# UNITED STATES PATENT AND TRADEMARK OFFICE

10/804,958

<b>Office Action Summary</b>	<b>Application No.</b> 10/804,958	<b>Applicant(s)</b> VO ET AL.	
	<b>Examiner</b> ERIN D. CHIEM	<b>Art Unit</b> 2883

### **DETAILED ACTION**

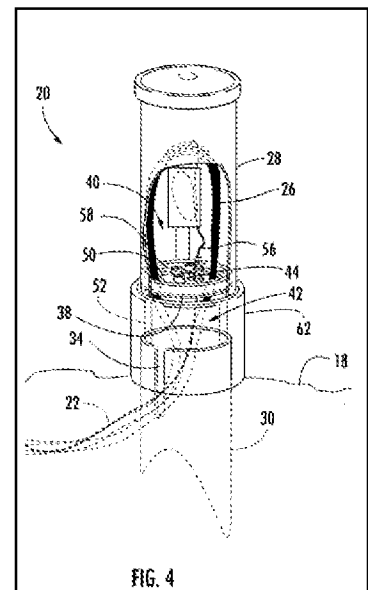
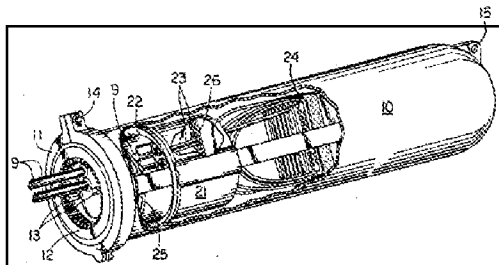
In terms of claims **1-4, 17, 20-21, and 28-29**, O'Neil teaches a splice pedestal comprising a base (Fig. 1; '12' '21' '24' and see also Fig. 7), a housing (10) positioned over the base, a distribution cable (9) received within the interior cavity, a plate (26) secured to one of the housing and the base and operable for separating the interior cavity into a first compartment (not explicitly drawn but explained in col. 2, lines 52-57) disposed within the housing and a second compartment (21). A splice tray (24) means for interconnecting. Furthermore, a plate (26) sealing the first compartment relative to the second compartment and the gel is only filled from (21) to (25), which is the first compartment and the second compartment are substantially

free of a gel encapsulant material. O'Neil discloses at least one cable port for routing the distribution cable into and out of the first compartment (9). At least one optical fiber of the distribution cable is spliced to the at least one optical fiber of the drop cable in the first compartment (col. 2, lines 30-54) and wherein the means for interconnecting comprises at least one splice tray (24).

However, O'Neil discloses a gel encapsulant material in the first and/or second compartment.

Clapp discloses a fiber optic closure with couplers and splice tray. As Fig. 1 shows the splice tray and the separation of the first and the second compartment separated by the plate or referred to as the "end cap" by Clapp Jr. Furthermore, Clapp discloses the end cap seals the enclosure without any gel encapsulant material. **The motivation** is obvious in the improvement of the Clapp over O'Neill since there is no gel encapsulant is required. The enclosure can be removed and the internal members can be worked on or replaced without having the deterrent of the gel encapsulant material and/or replace the gel encapsulant material in order to seal the enclosure.

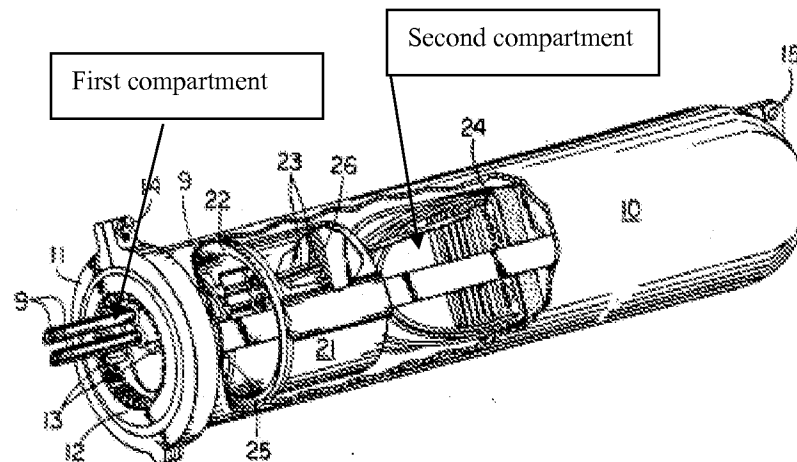
Examiner would respectfully point out Clapp refers to the plate which separates the first and second compartment as end-cap but still reads upon applicant's claimed first and second compartments. However, Fig. 4 is extract from applicant's disclosed figures clearly shows the plate (38) creates the barrier between the first and second compartment is also the end-cap since

plate 38 functions as the sealing structure and the so-call first-compartment is merely the open space that is formed within the cylinder between plate 38 or end-cap 38 with the ground.

Applicant does not distinctly disclose the patentable distinction between the “first compartment” shown in Fig. Between the space in the phantom lines and the “first compartment wherein the cables (9) are extending from.
